ADDENDUM NO. 2

Reference: Vernal Game Farm New Shop and House Renovation
Division of Wildlife Resources – Vernal, Utah
DFCM Project # 07319520

ADDENDUM NO. 1
Date: May 26th, 2009

Vernal Division of Wildlife Resources
New Shop Building, Office Remodel and Site Improvements
Vernal, Utah

A-FP100

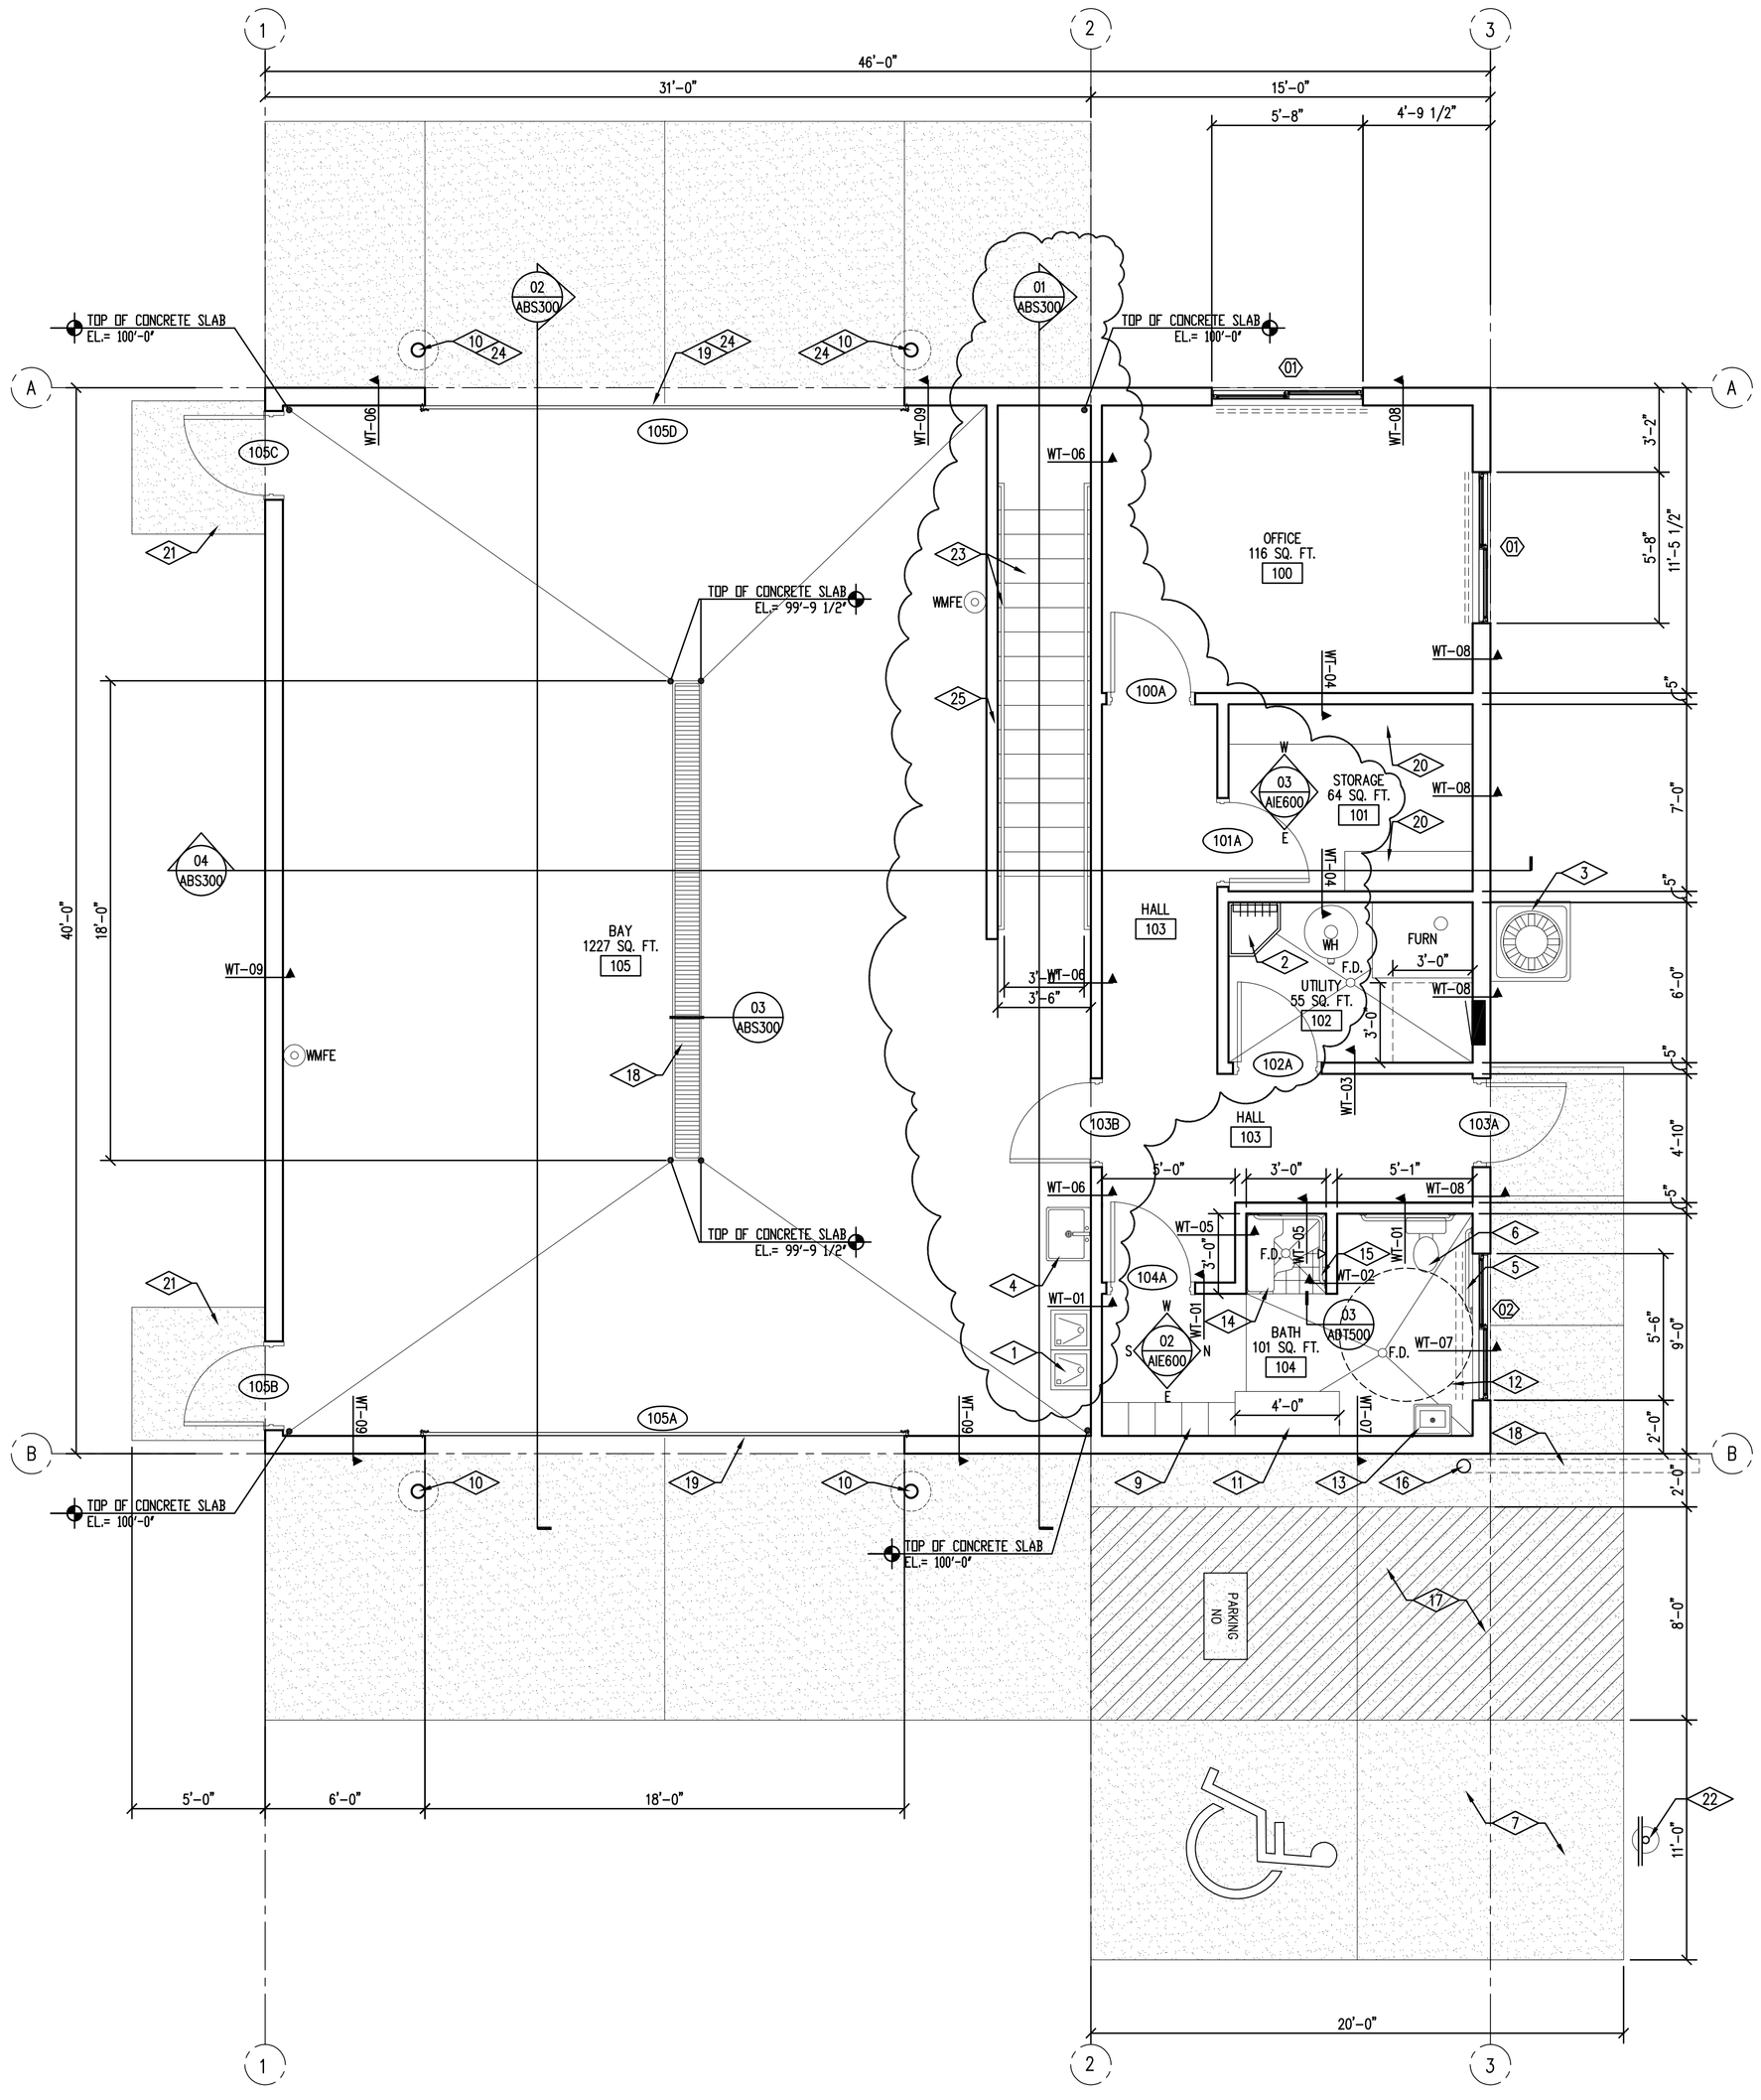
2. See revised drawings A-FP100, A-BS300, A-WS401. Note changes to floor plan and new stair configuration. The ships ladder as per the original plans will not be provided.

1. See drawing EL-101 for new shop area. Provide one additional light fixture type F-2 to be located in Hall 103 as per the new architectural floor plan (see drawing A-FP100 per this addenda) provide all necessary conduit and wiring required for installation.

A-WS400

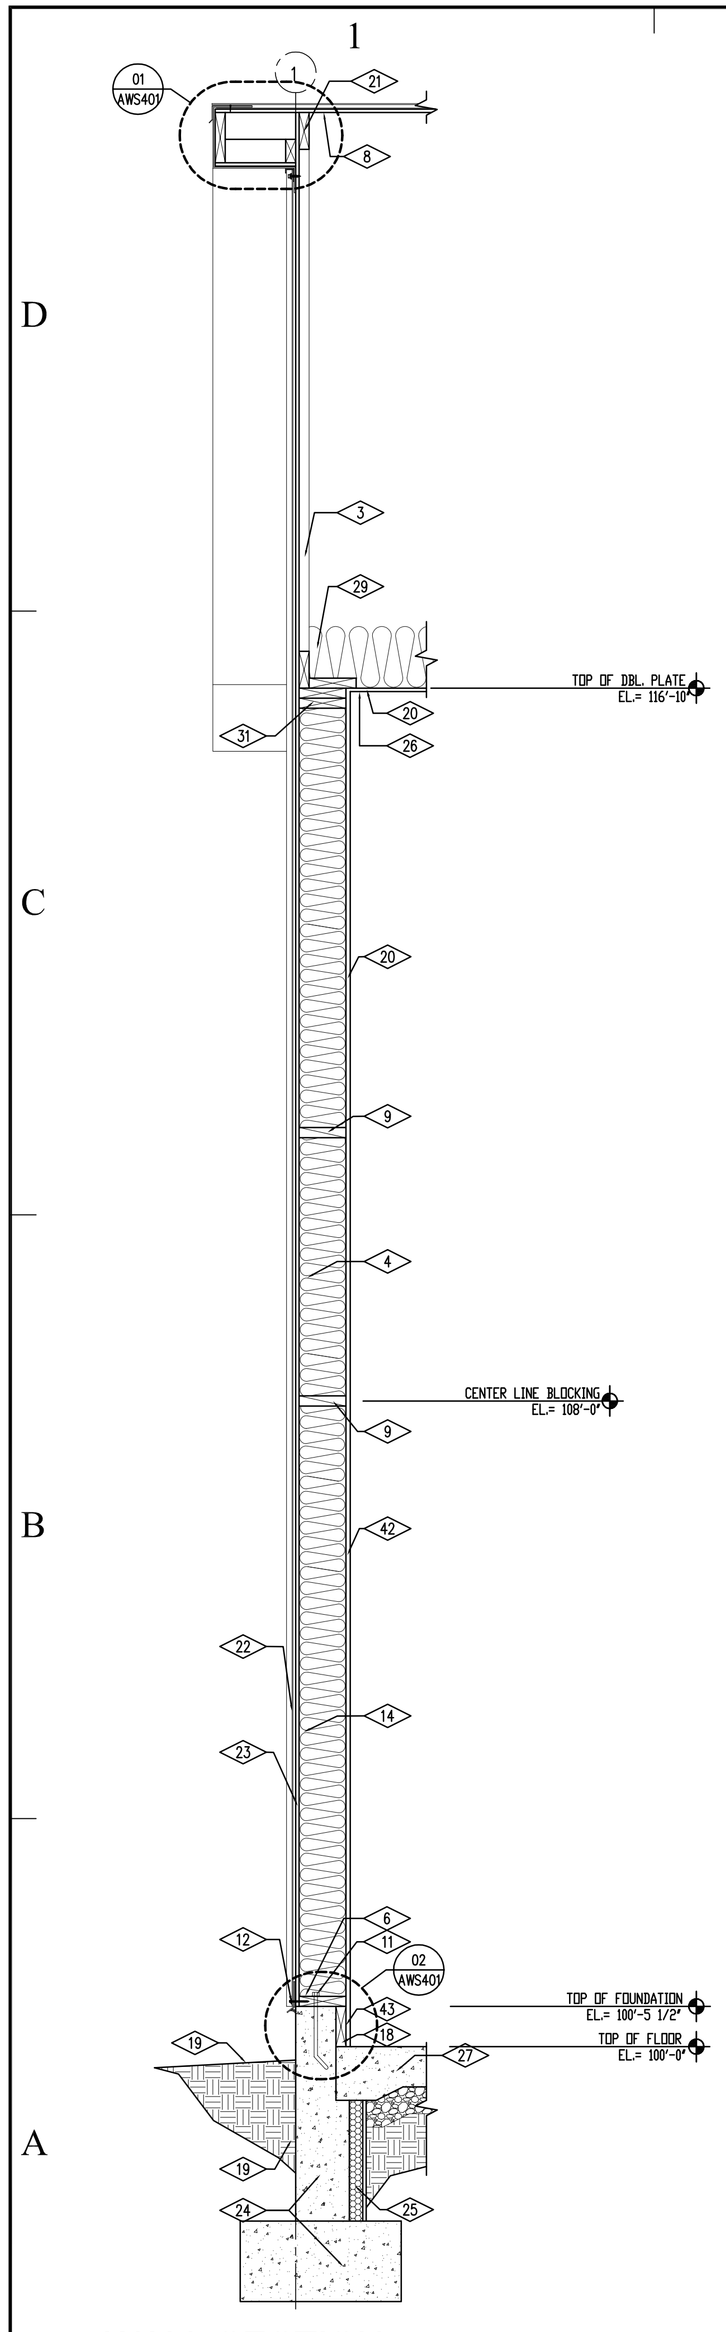
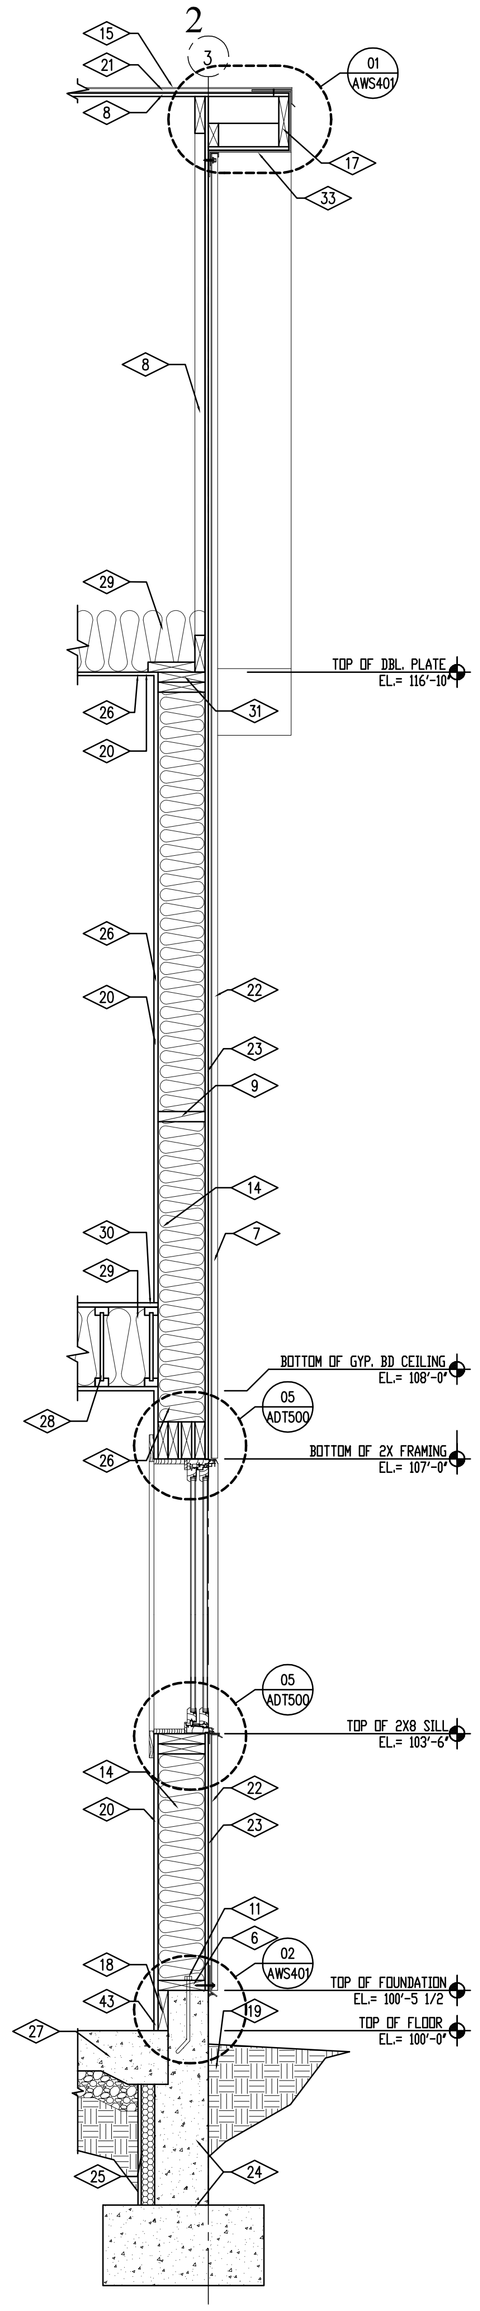
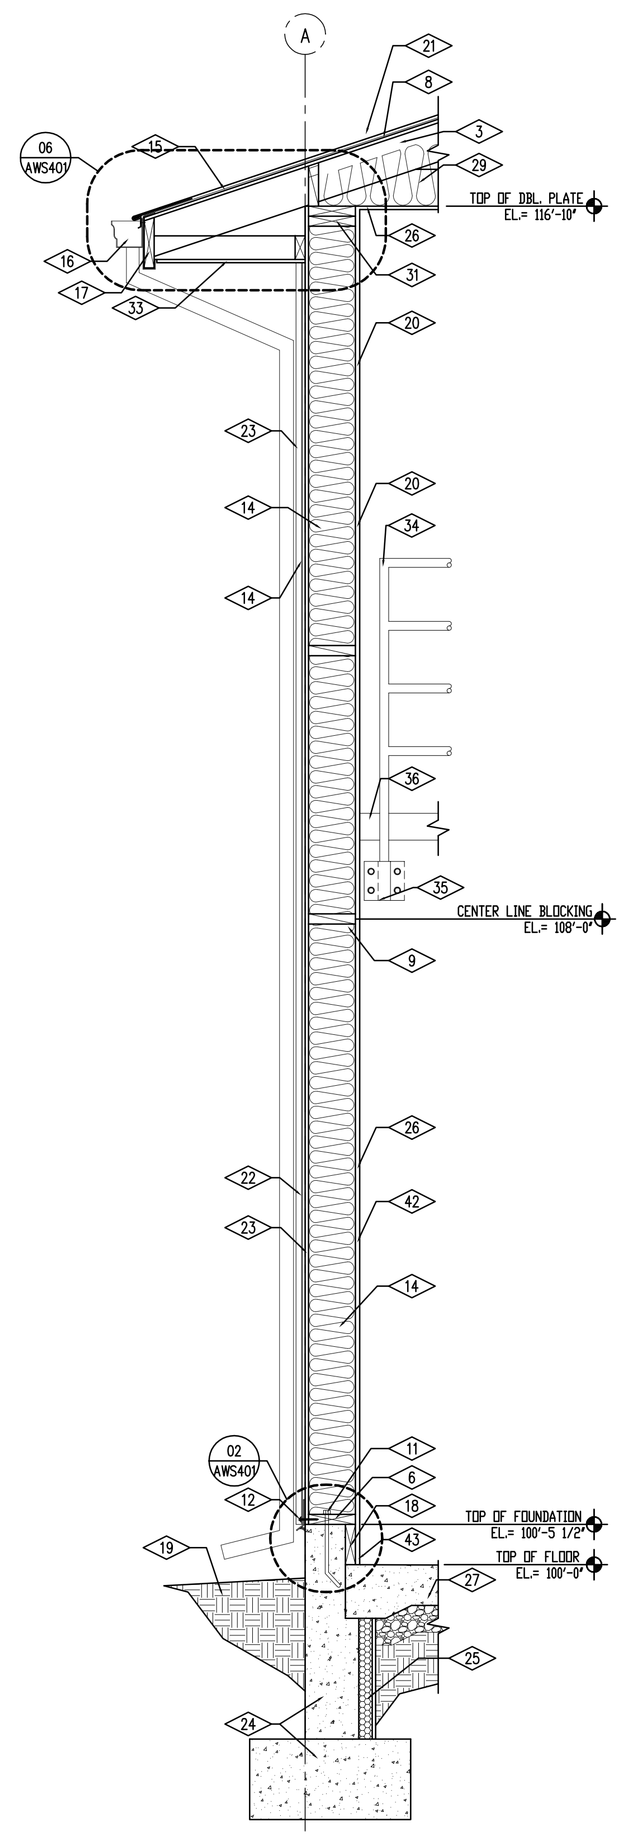
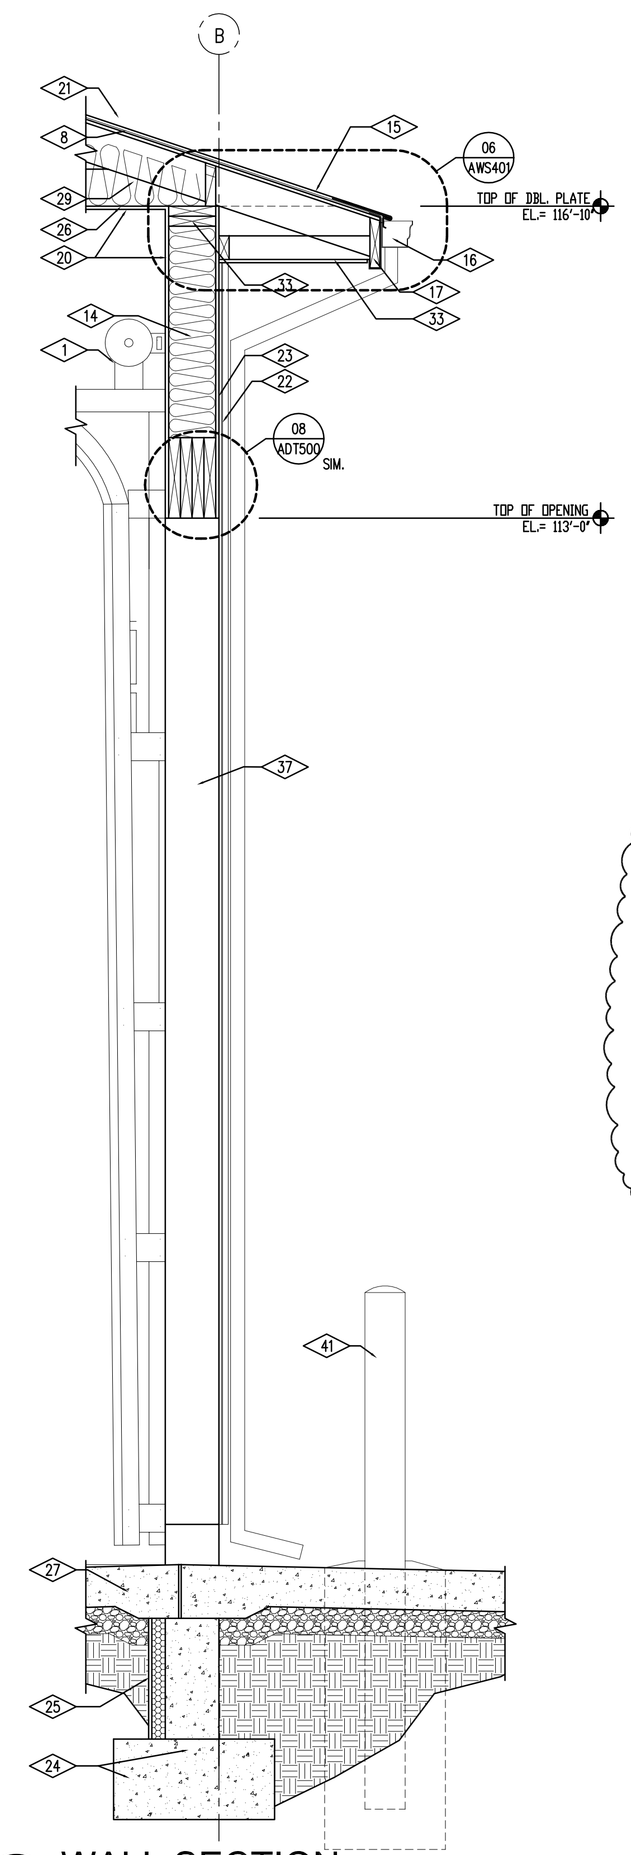
1. See revised drawings A-WS400. Note bubbled area with additional reference notes.
